KEWAUNEE NUCLEAR POWER PLANT

Amendment No. 16
License No. DPR-43

ATTACHMENT TO LICENSE AMENDMENT NO. 16

SUPPORTING AMENDMENT NO. 16 TO FACILITY LICENSE NO. DPR-43

FIGURE 153-0-2 HOT CHANNEL FACTOR
NORMALIZED OPERATING ENVELOPE

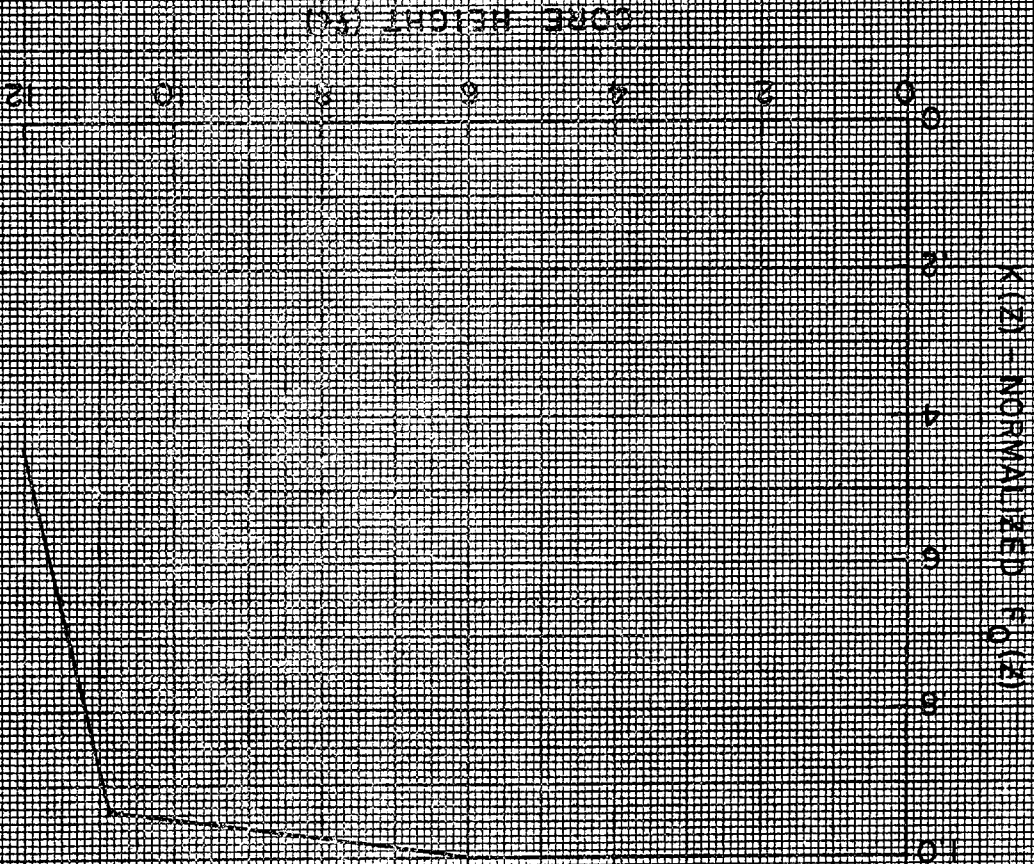
Based on reanalysis of the ECCS F_Q was increased to 2.25. This required modification of the hot channel factor normalized operating envelope (Fig. TS 3.10-3) and a change of the accumulator water volume. The two additional changes proposed by WPSC, but not related to the ECCS reanalysis, are an improved definition of the operating limits for the axial flux difference (Fig. TS 3.10-6) and a change in reactor coolant boron concentration during refueling operation.

The modification of the hot channel factor normalized operating envelope is required because increased peaking factor affects the linear heat generation rate (LHGR) limits at all core elevations except for the upper part of the core where these limits are controlled by a small break LOCA. In this region the LHGR limits remain unchanged because the original small break LOCA analysis, performed with the peaking factor of 2.32, is still applicable. Upon normalization to the maximum LHGR value (licensed value), the third segment of the curve, corresponding to the small break LOCA, is slightly displaced and the intersection between the third and the second segment of the curve moves down the core elevation. This modification is illustrated in proposed Fig. TS 3.10-2.

The modification to Figure 3.10-2 is acceptable because it reflects changes in the new ECCS analysis. Similarly, the changes in accumulator liquid volume to 1250 + 25 ft is consistent with the new ECCS analysis input. We conclude that these changes are acceptable.

FIGURE TS-310-6 TARGET BAND ON
INDICATED FLUX DIFFERENCE AS A
FUNCTION OF OPERATING POWER

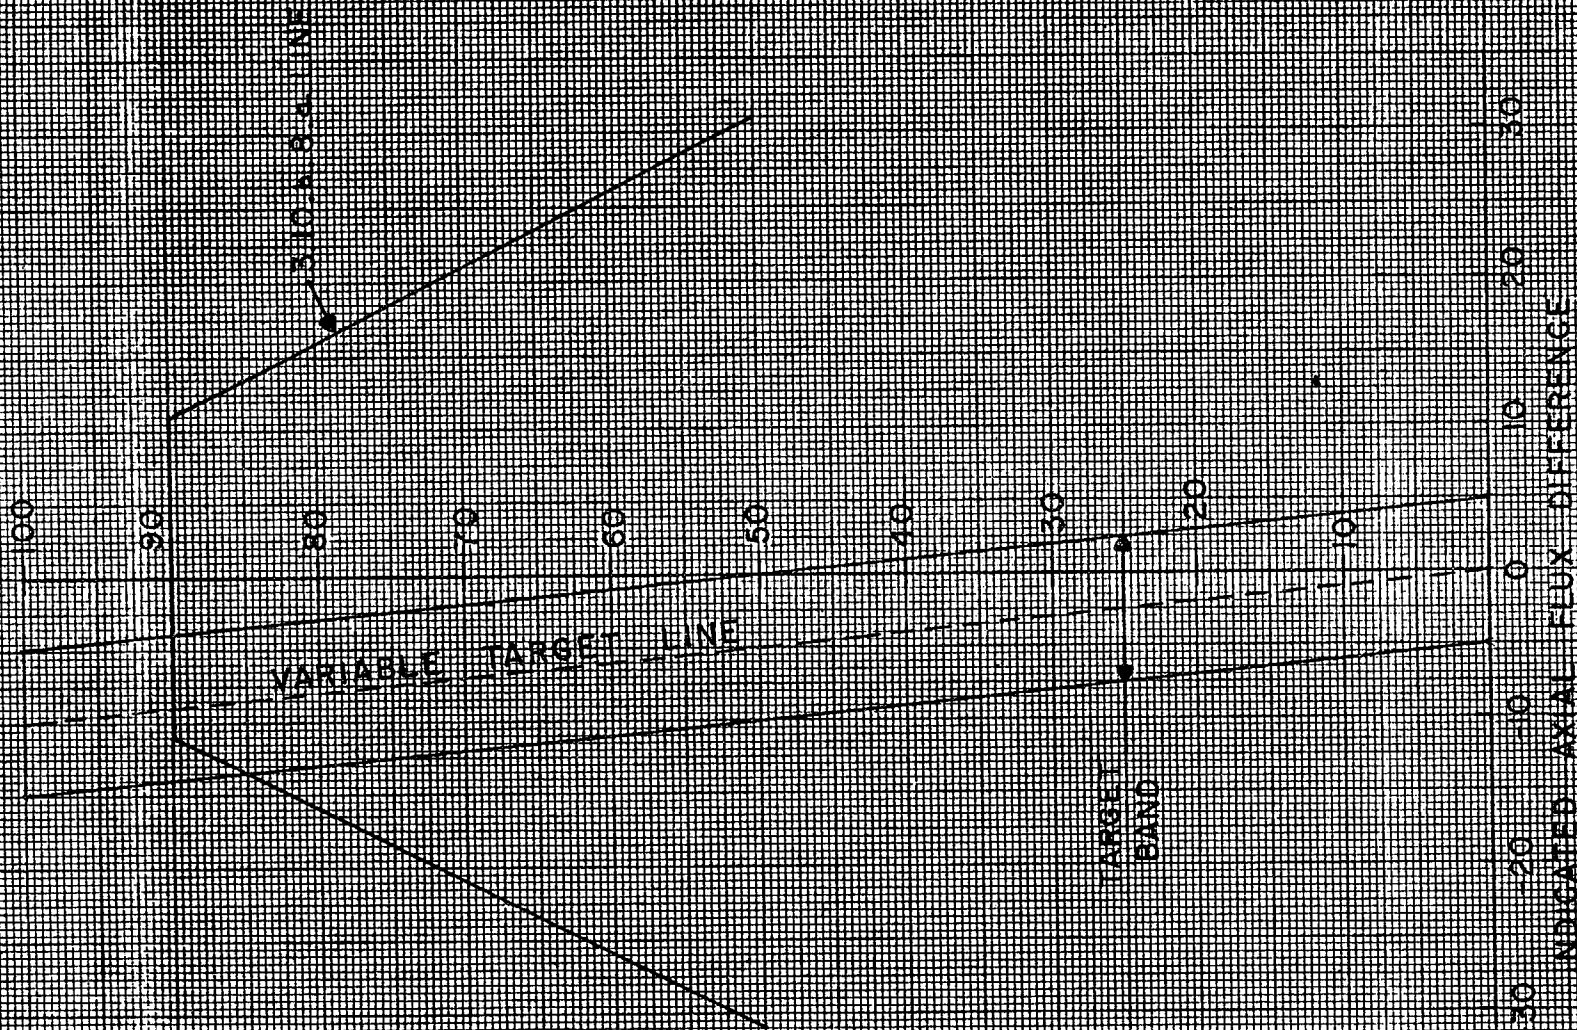
The revision to the flux difference curve (Fig. TS 3.10-6) consists of including an additional operating target band for the flux difference applicable when the reactor is operated at 90 percent of rated core power or less. This change is consistent with the power distribution control methodology developed by Westinghouse (Reference 10). Since this change provides additional clarification, we find it to be acceptable.
